Re: NYSEIA Comments Regarding the PSC's solicitation to Utilities for Changes to the Standard Interconnection Requirements

SIR Process for Systems Greater than 25kW up to 2MW

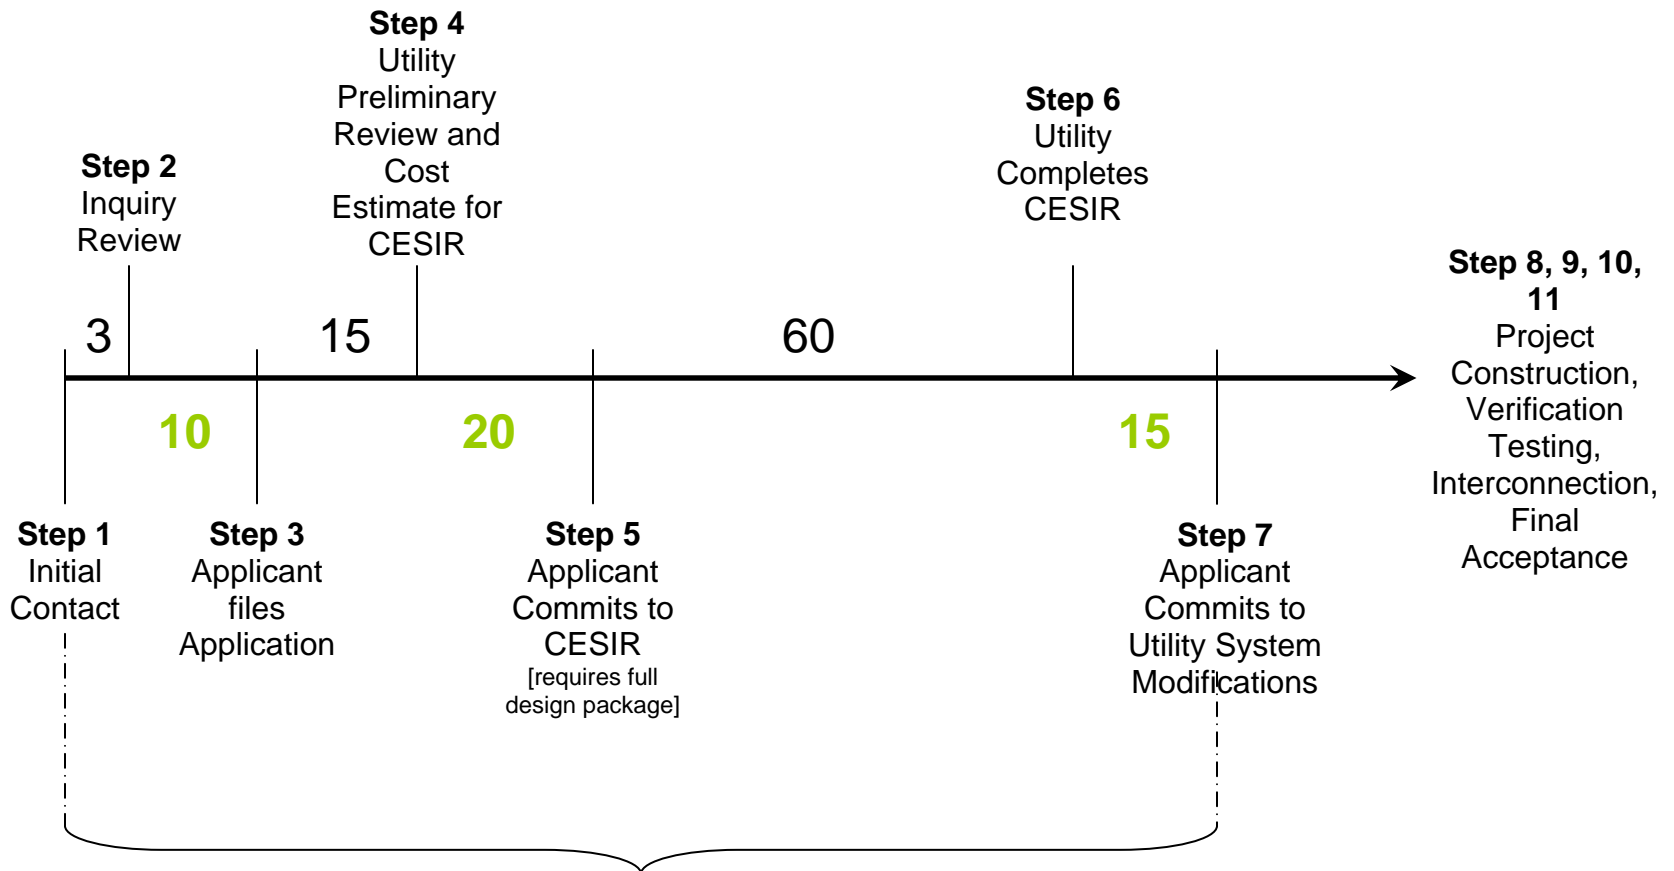
Regarding the procedures and steps related to systems above 25 kW and up to 2MW's, the overarching comment is that the durations afforded the utilities for various steps in the procedure are not commercially acceptable for customers looking to make an interconnection.

If New York State is committed to propagating solar generating facilities in a meaningful fashion, the various bodies that regulate, fund and implement these projects must have coordinated policies and procedures. Accordingly, it is our recommendation to change the allowable durations called out for the 25kW to 2MW categories as follows according to each respective STEP.

Steps 1 through Step 7 Potential Duration per SIR is over 24 weeks, or 6 months. Leaving very little room, approximately 2 months, for construction and testing for NYSERDA projects

- Revise allowable duration between Step 3 and Step 4 to be 10 working days.
- Revise allowable duration between Step 5 and Step 6 to be 30 working days.
